# Access Compliance Report

## Public Rights-of-Way

| Intersection ID: 23663                  | Main Street: S_TRYON_ST | Cross Street: ERWIN_RD                  | Location: W            |
| ADA ID: 296763C550F3                    | Ramp Type: MedianPerp   | Initial Pass/Fail: Fail                 | Overall Compliance: No |

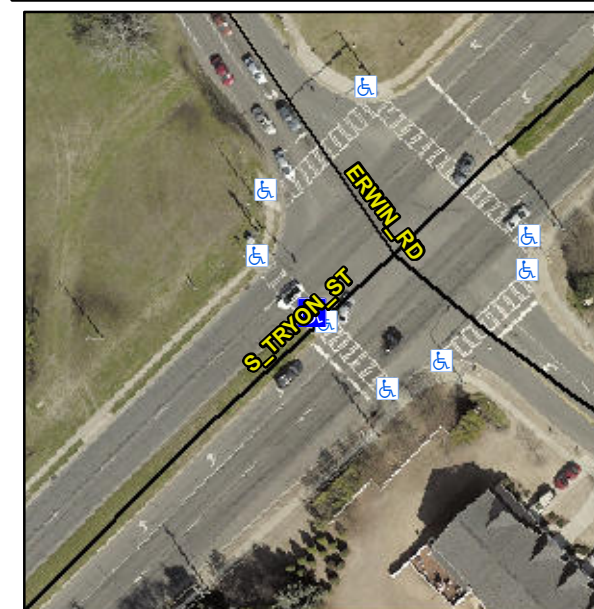
**Not Found, R304.5.1**

| Compliance | Description           | Data  | Compliance | Description                 | Data |
|------------|-----------------------|-------|------------|-----------------------------|------|
| No         | Ramp Width (in)       | 47.0  | Yes        | Ramp XSlope (%)             | 1.4  |

**Remove & Replace Entire Ramp.**
